# SERVICE BULLETIN REVISION NOTICE

NACELLE – EXHAUST – LUG, THRUST REVERSER LOWER OUTBOARD TRACK ASSEMBLY  
LANYARD ATTACH – MODIFICATION OF

Turbojet Engine Service Bulletin No. V2500-NAC-78-0225 Revision No. 1 dated May 9, 2017

NACELLE - EXHAUST - LUG, THRUST REVERSER LOWER OUTBOARD TRACK ASSEMBLY LANYARD ATTACH  
- MODIFICATION OF

OUTBOARD TRACK ASSEMBLY LANYARD ATTACH LUG  
Fig.1

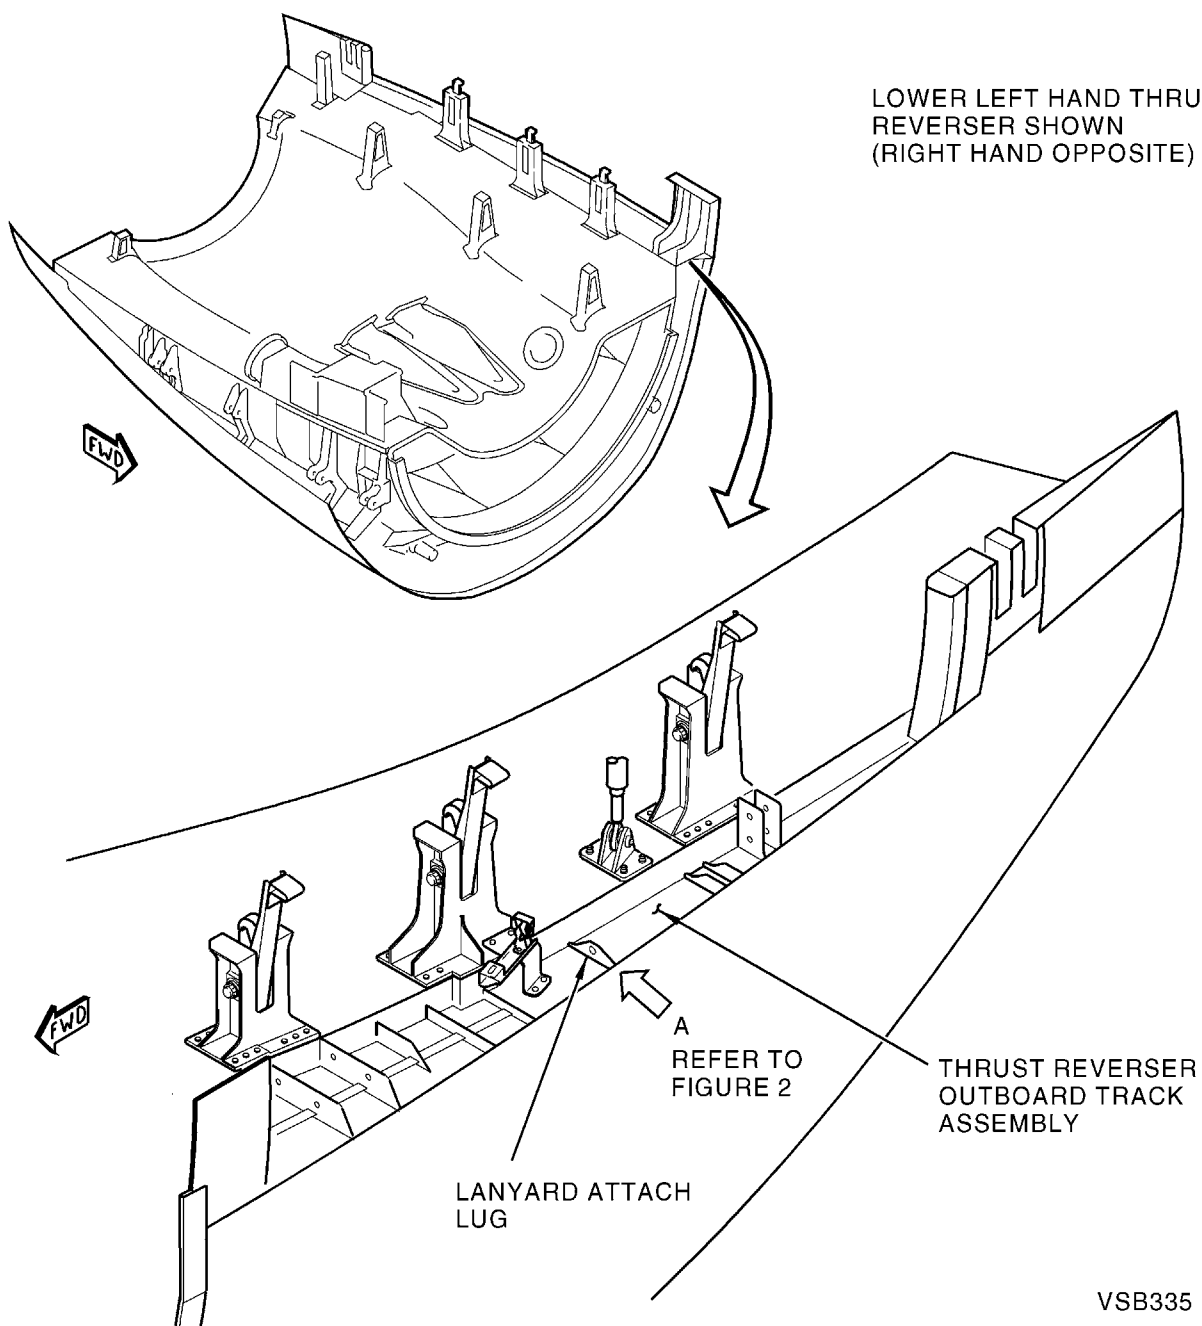
- (a) Carefully pull back insulation blanket on outboard track assembly of left hand lower thrust reverser to get access to rework area. Refer to Figure 1.
- (b) If installed, remove S700B0116-5C8 or S700B0116-5C16 bushing. Refer to Figure 2. Discard bushing.
- (c) If installed, remove 94-B043600-M angle bracket. Discard bracket.
- (d) Remove material from track assembly as shown in Figure 2.
- (e) Clean away metal chips or other unwanted material with dry air supply.

LANYARD FITTING HOLE LOCATIONS  
Fig.3

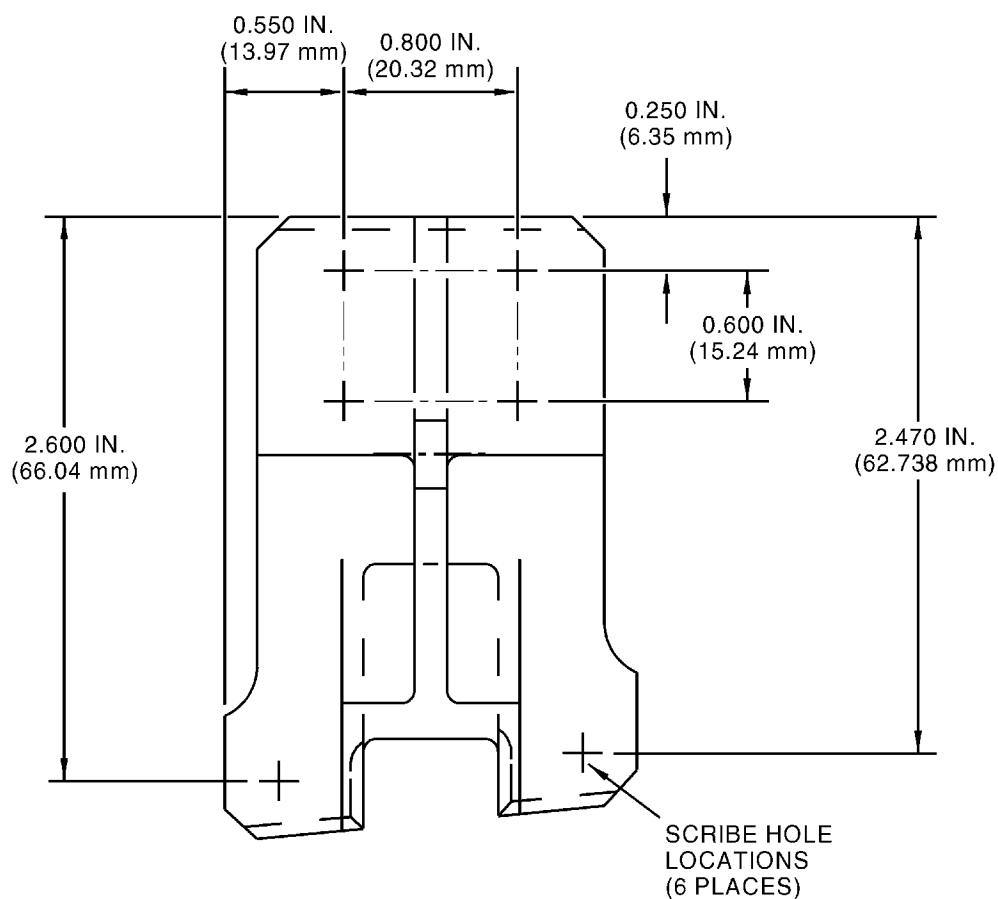
- (1) Make a mark for hole locations on 290M0003–5. Refer to Figure 3.
- (2) Attach with a clamp 290M0003–5 fitting and two 290M0003–3 radius blocks to lower track assembly. Refer to Figure 4.
- (3) Drill fastener holes through fittings, lower track assemblies, and radius blocks.
